# **ASR Feasibility in Bandera County**

**Plateau Region Water Planning Group  
and  
Texas Water Development Board**

# Response to TWDB Comments on Draft Final Region-Specific Study Reports

## Region J, Region-Specific Contract Study #2 *Water Rights Analysis and ASR Feasibility in Kerr County;* *ASR Feasibility in Bandera County*

**Figure 3.1 Annual diversions from the Medina River in the vicinity of the City of Bandera**

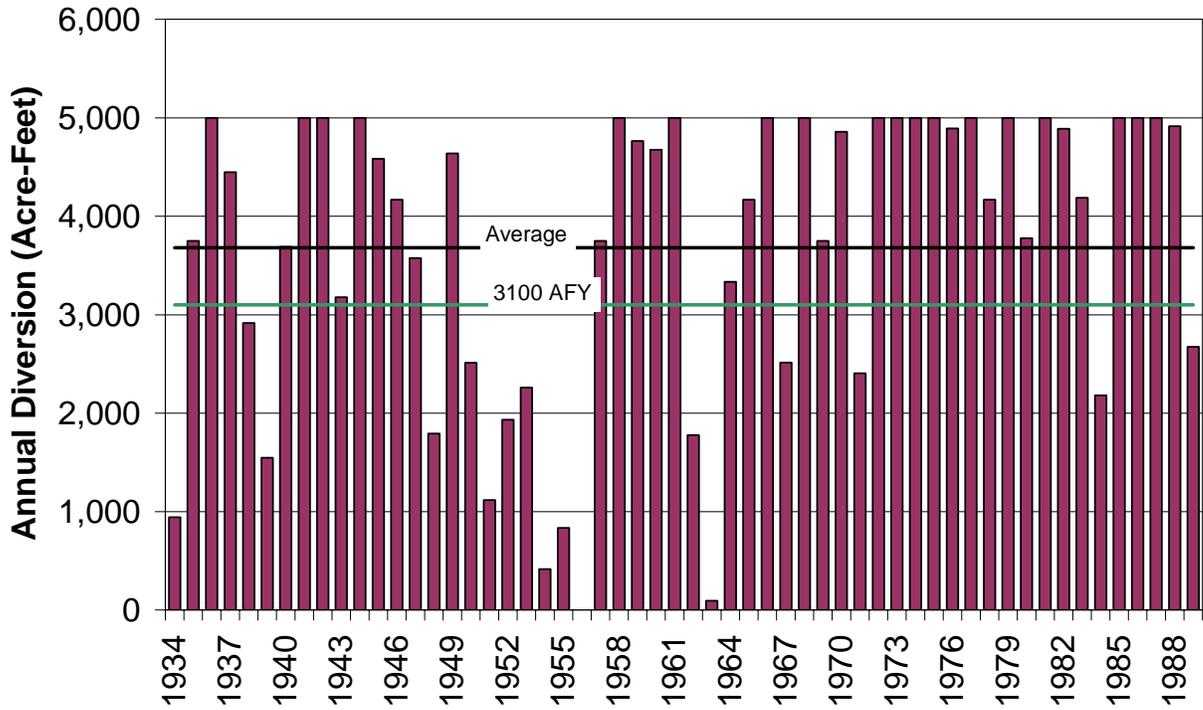
4. Report 2, Page 3-3, Figure3.1: Please add units to the axes of the graph in the final report.

*Response: Units are added to the graph.*

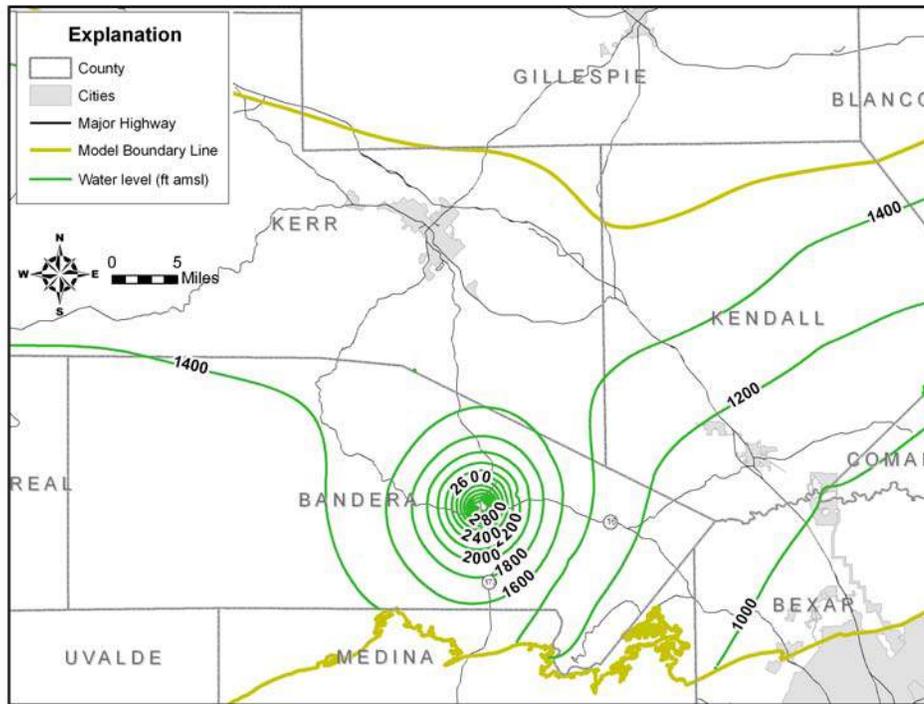
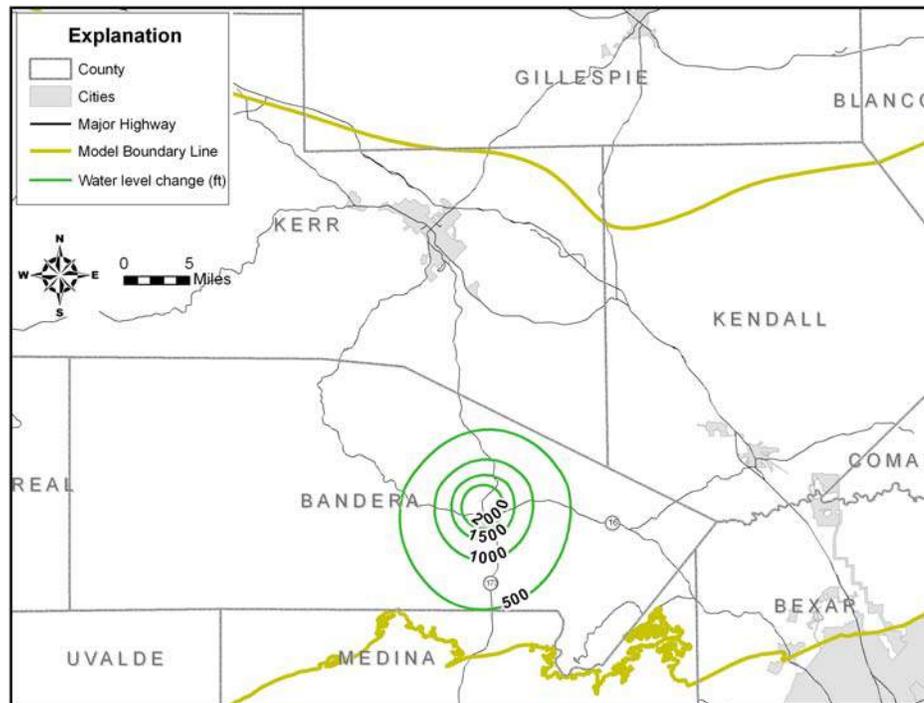
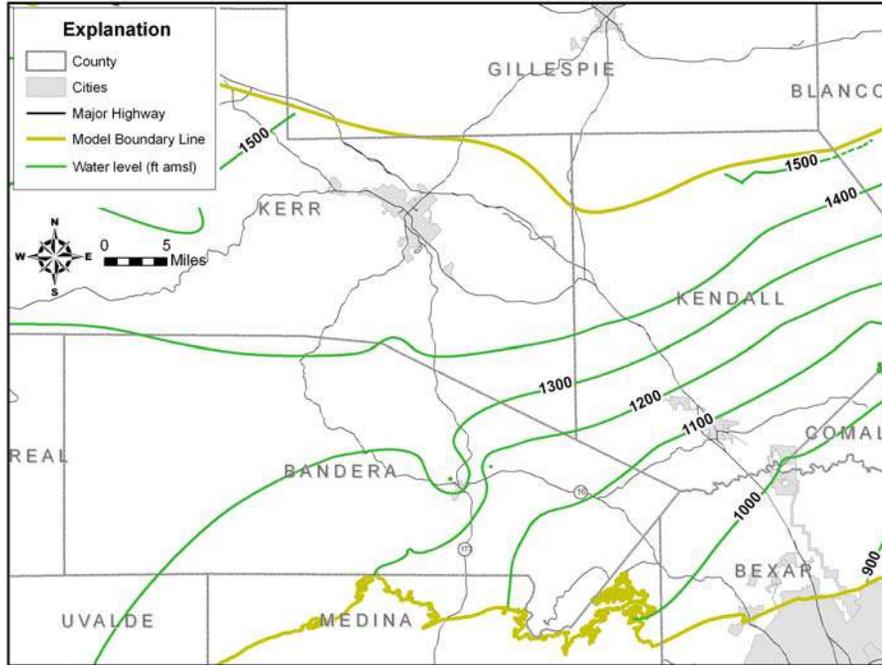
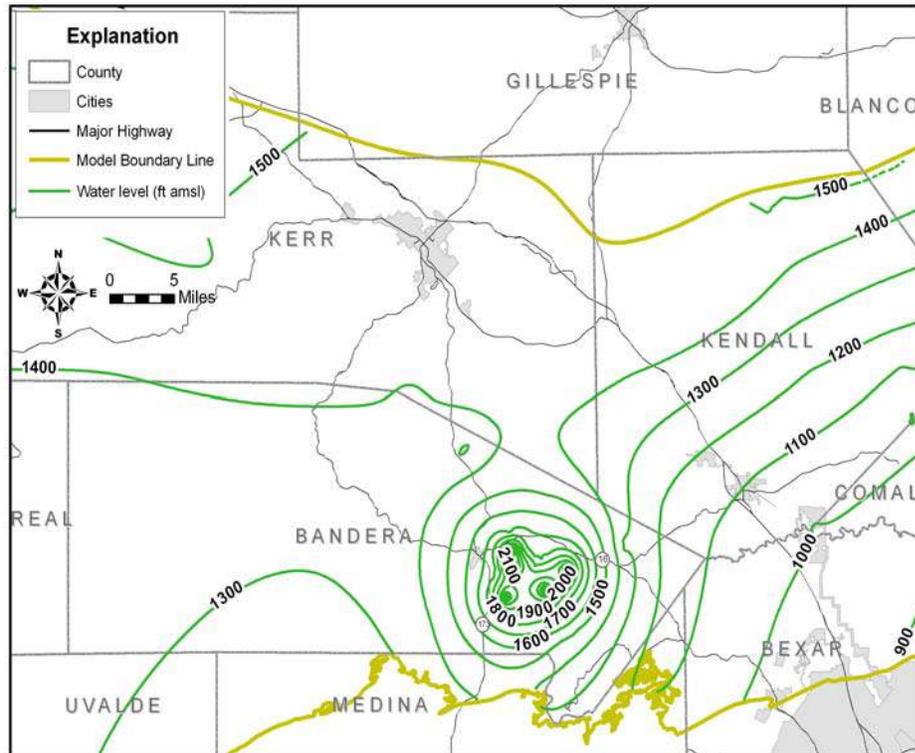
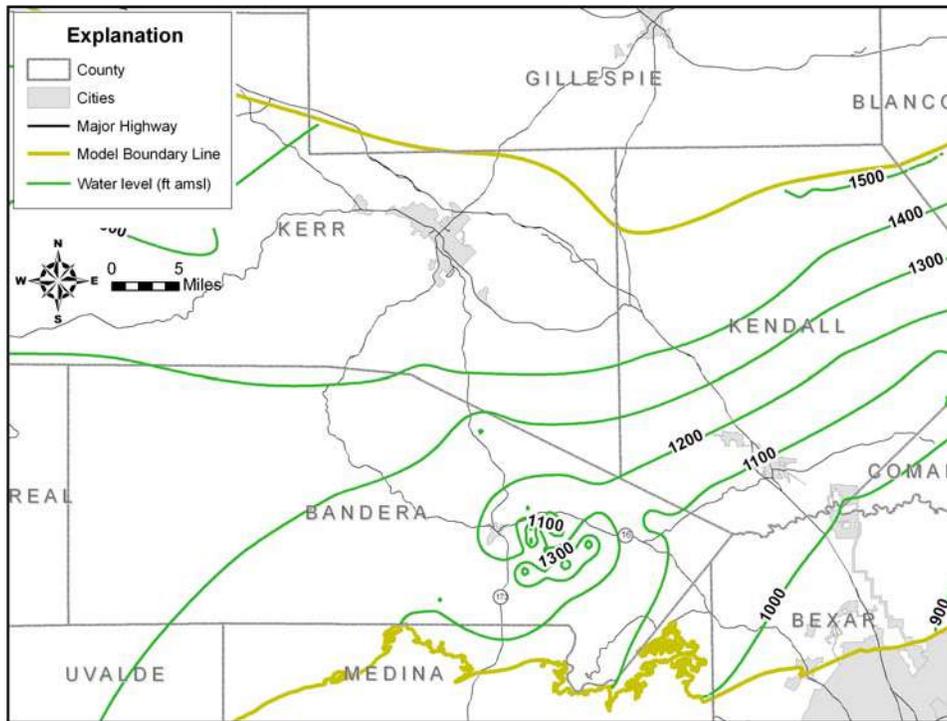
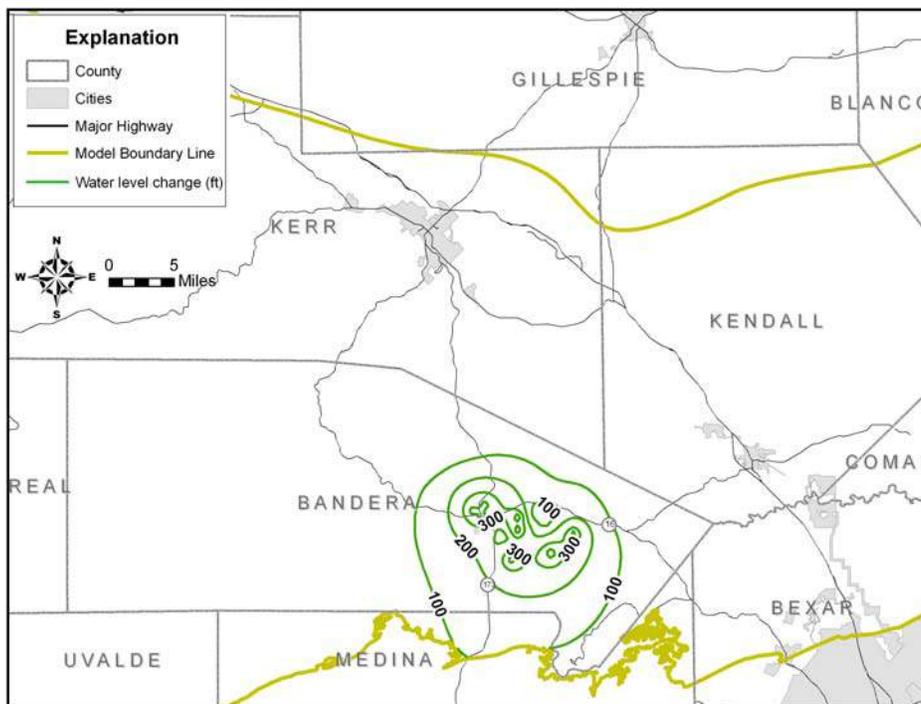
8. Report 2, Section 5 Figures: (a) pages 5-4 to 5-7, Figures 5.1 to 5.7: Please identify the year for which water levels and water level changes are shown in these figures; (b) page 5-6: Please consider including water levels and water level changes for Scenario 2a in the final report.

*Response: Figure titles have been revised to show conditions in 2060. Figure 5.5 now shows the Scenario 2a conditions.*
